Title:	BCR Bad Reading at Transfer Station			ID:
				0010
Date in:	Response:	Model:	Author:	
2006-08-14	2006-08-14	-	CMa

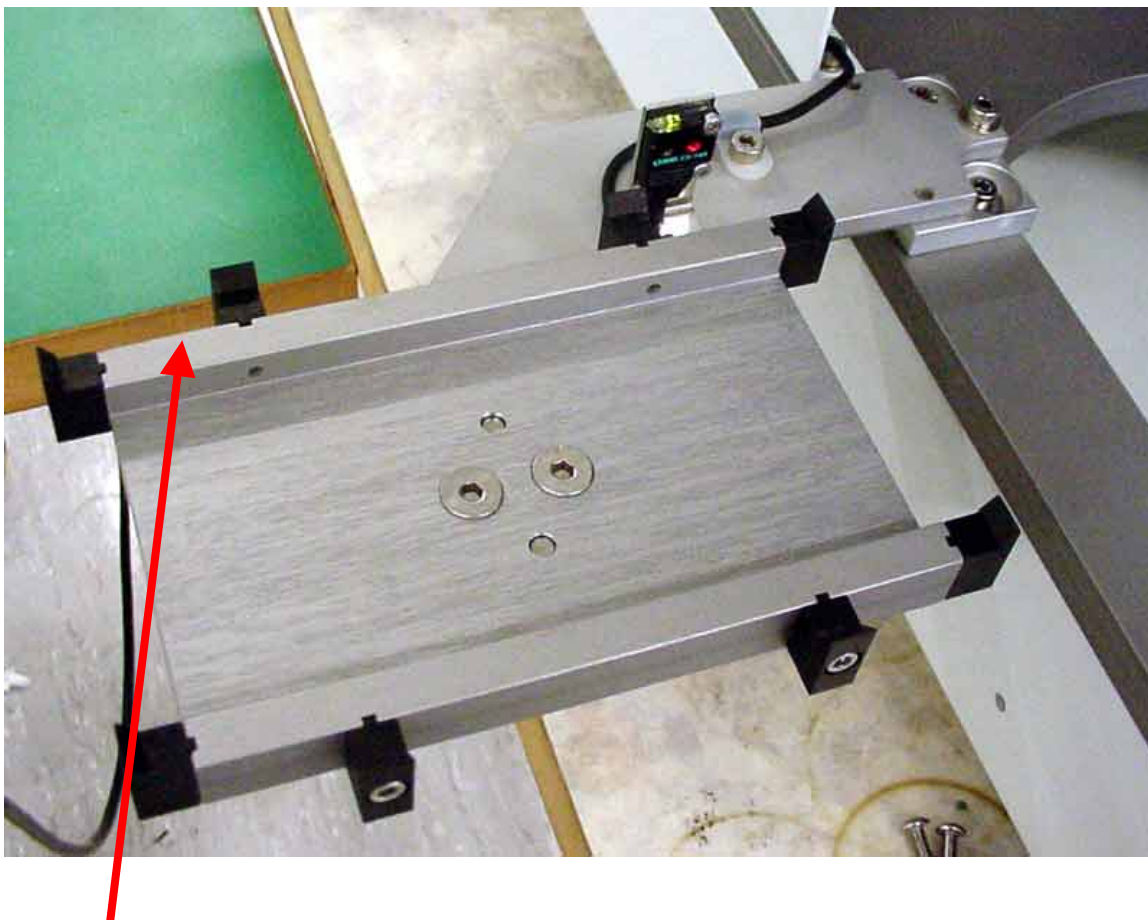
We observe unreliable reading of the BCR at the transfer station. The beam is centered nicely on the barcode. The reading in the stackers is ok.

On clear plates there could be interferences between the BCR and the plate detection sensor of the transfer station.

Please have the sensor placed in the location of the Arrow, this is what I did for Astra on the STX 1000 to eliminate the reading of the BCR issue at the transfer station
